A G E N D A JAMES CITY COUNTY DEVELOPMENT REVIEW COMMITTEE REGULAR MEETING

Building A Large Conference Room 101 Mounts Bay Road, Williamsburg, VA 23185 July 27, 2016 4:00 PM

SUBJECT: The Promenade at John Tyler: Appeal of a decision of the Director of Planning

SITE PLAN-0052-2016. Williamsburg Memorial Park Ossuary

PROMENADE AT TYLER DUPLEX SCHEME 3

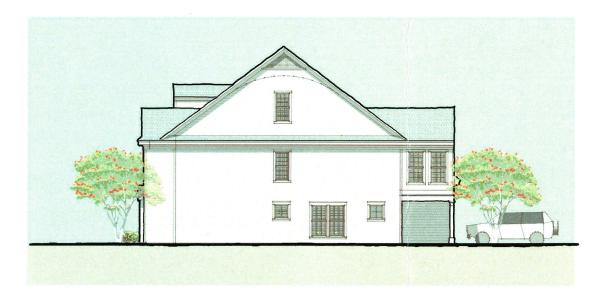
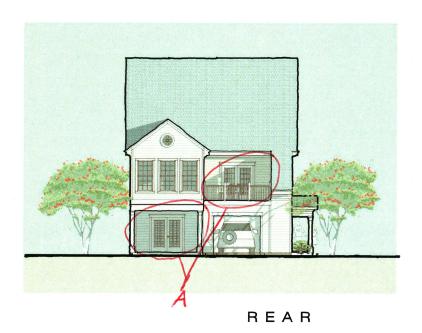
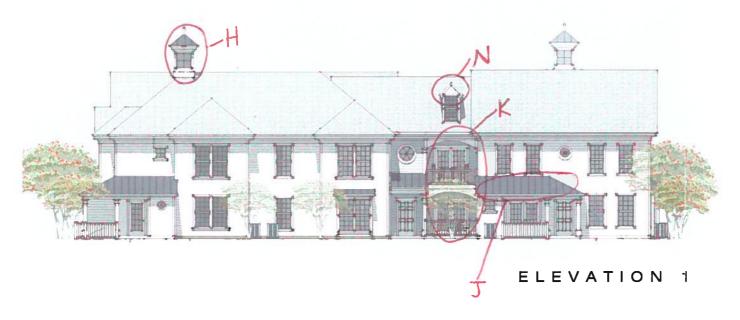
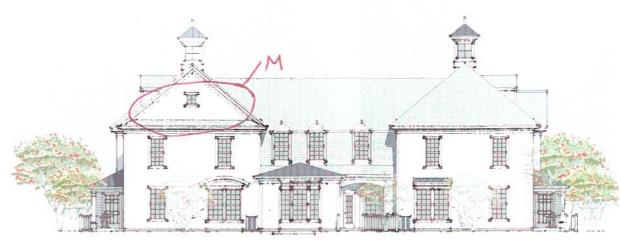
Staff and the Planning Director identified the following inconsistencies between the two sets of elevations (also highlighted by letter in Attachment No. 1):

- c. The CIS elevation shows the bottom right windows to be grouped, creating a box window with arched detailing. This feature should be included in at least three of the elevations.
- d. The CIS elevations show a semicircle window at the top right of the duplexes. This feature should be incorporated into the elevations.
- e. The standing seam on the lower roof lines shown on the CIS elevations should be included on all buildings.
- f. White trim should be provided on top of the dormer window on Duplex 3, as shown on the other buildings.

- b. The CIS elevations show two cupolas on each building, which are not included in the draft elevations.
- c. The small circular windows in CIS elevations 1 and 3 are features that should be included.

- d. The standing seam on the lower roof lines shown on the CIS elevations should be included on all buildings.
- e. The CIS elevations show a second level porch on two of the units. This feature is currently shown in one elevation, but should be added to at least one more. These are shown above a first level porch on the CIS elevations. Preferably, this layout would be carried through in at least one of the two elevations showing a second level porch.

- f. The rooflines in proposed Elevations A and C are very different than those shown on the CIS elevations.
- g. The CIS elevations show a small window in the roofline of Elevations 2 and 4 with siding is continued into this area.

- h. White trim on top of the dormer windows of Elevation B, as shown on the other buildings.

Given the above inconsistencies, the Planning Director has determined that the proposed elevations are not consistent with the elevations included in the application for rezoning, and would alter the character of the development as originally proposed during the legislative process. Staff recommends that the DRC find the proposal to be inconsistent with the master plan.

CONCEPTUAL PLAN

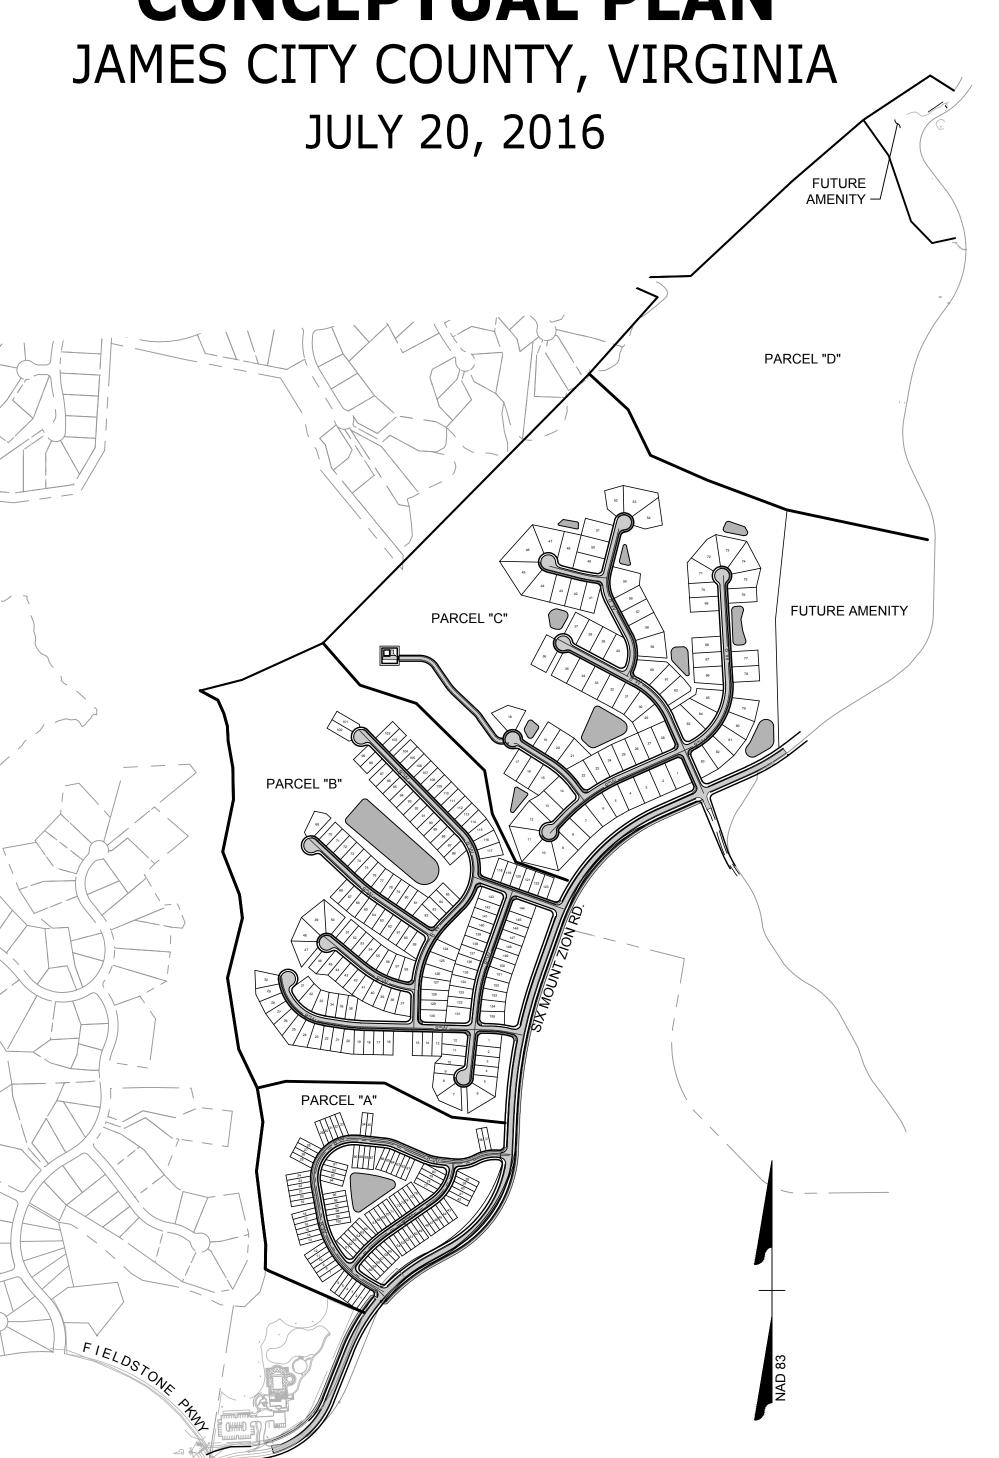
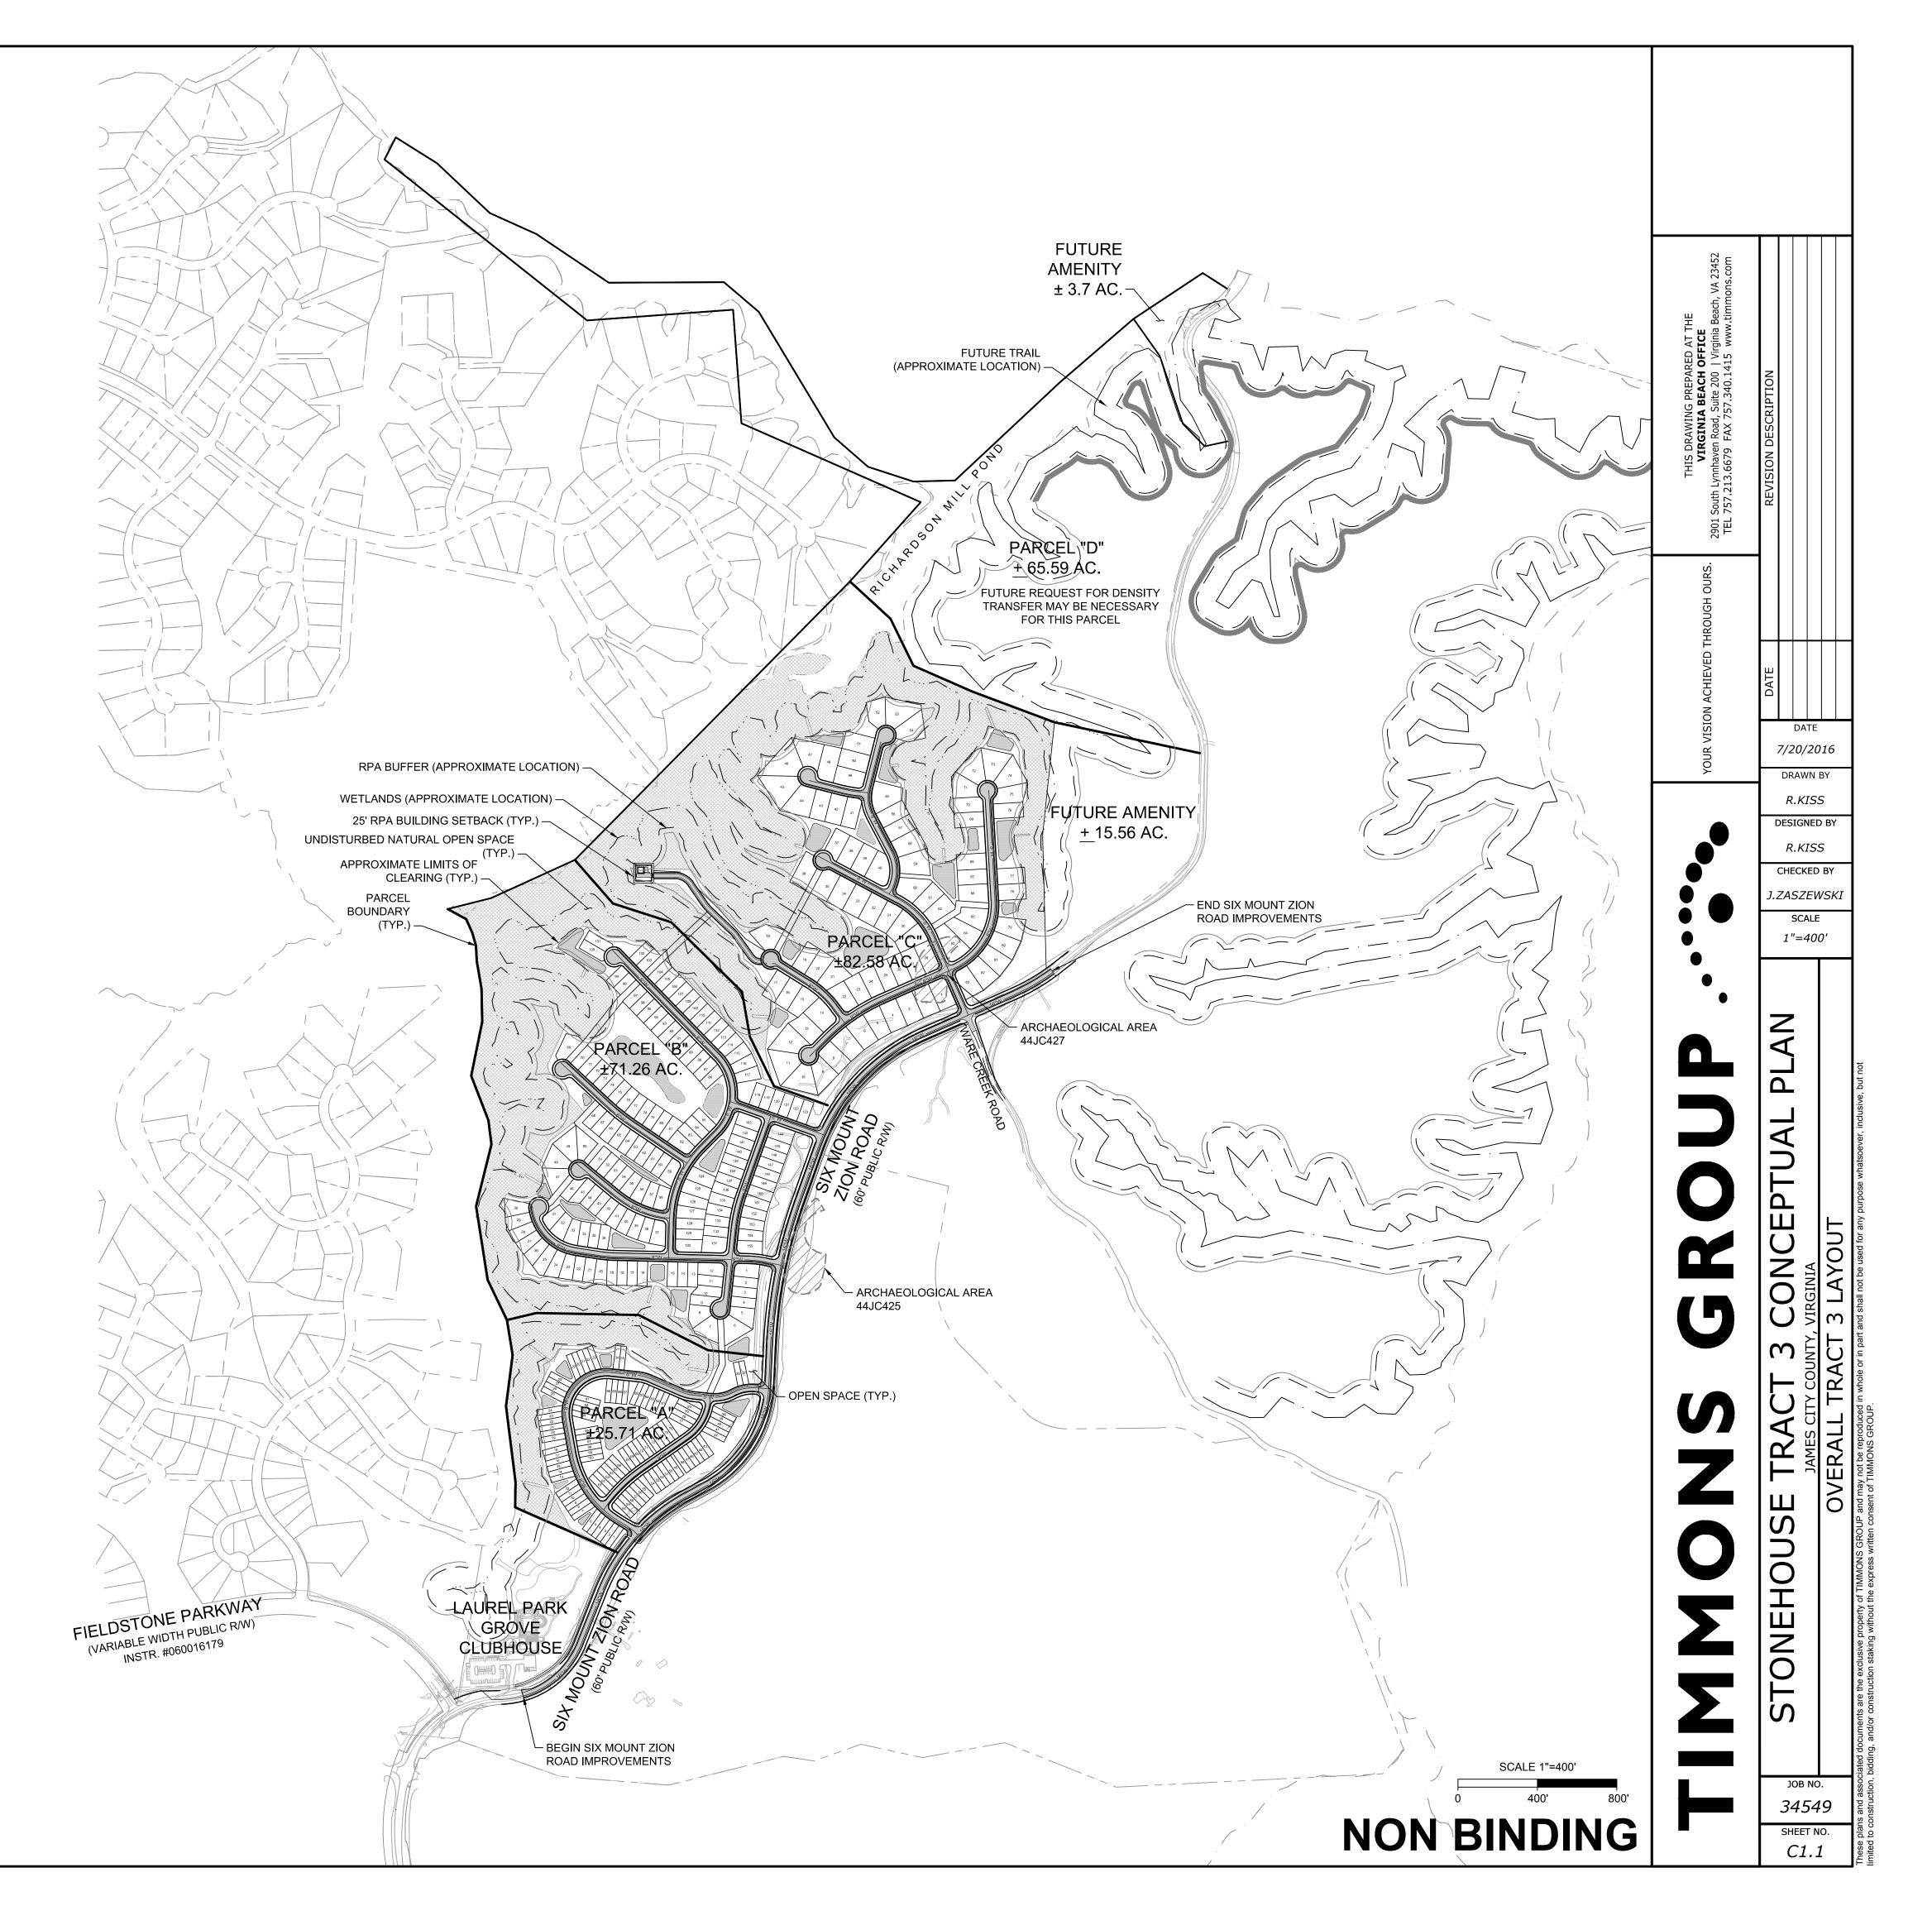
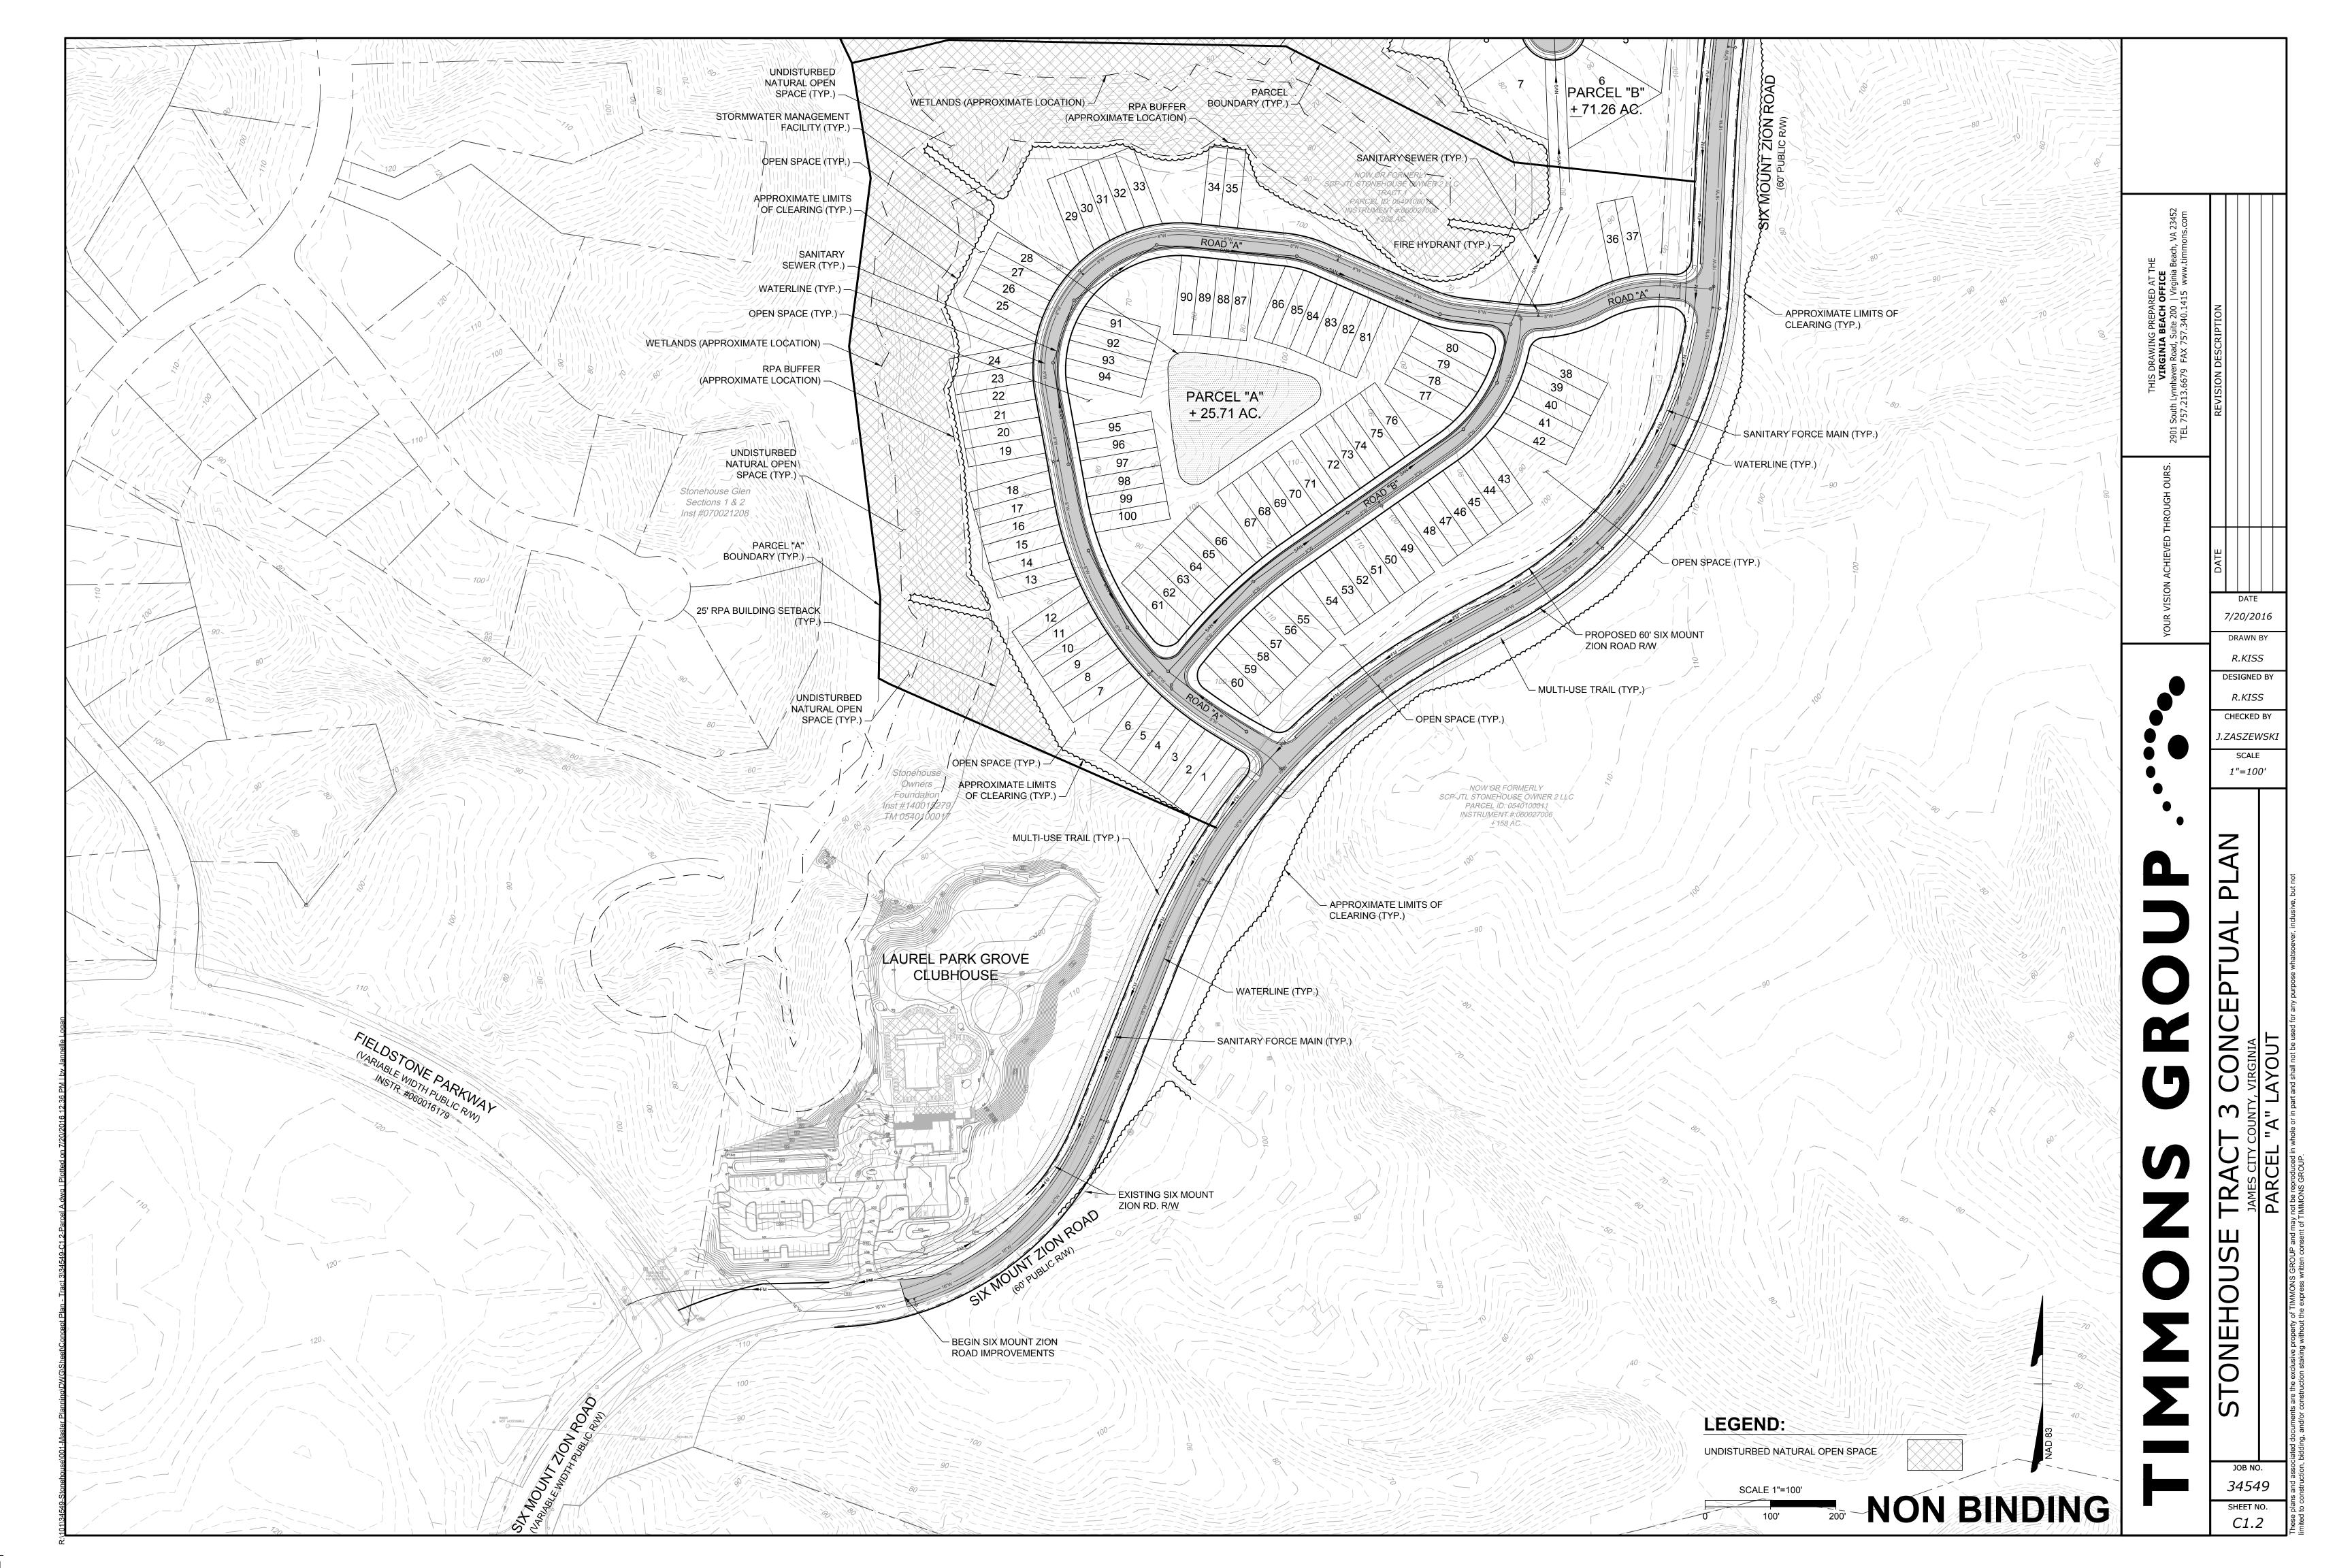
- be references to approved rezoning case Z-06-12 and Z-04-07 which have additional proffers applicable to this land bay.
- 4. Labels. On the conceptual plan cover sheet, provide a label to indicate Richardson Mill Pond with County BMP ID Code WC059. On conceptual plan drawing Sheets C1.1 and C1.2, label the Laurel Park Grove Clubhouse (ie. Amenity Center H) with text to identify approved County Plan No. SP-08-09. On Sheets C1.1 through C1.4 include text to indicate VDOT State Route number, as applicable, for Six Mount Zion/Holly Forks Road (ie. SR600, etc.).

- 19. BMPs. On detailed conceptual development plan Sheets C1.2 through C1.4 label the type of stormwater management/BMP facilities as proposed consistent with County BMP manual designations (ie. wet extended detention, dry detention, timber walls, dry swale, bioretention, etc.).
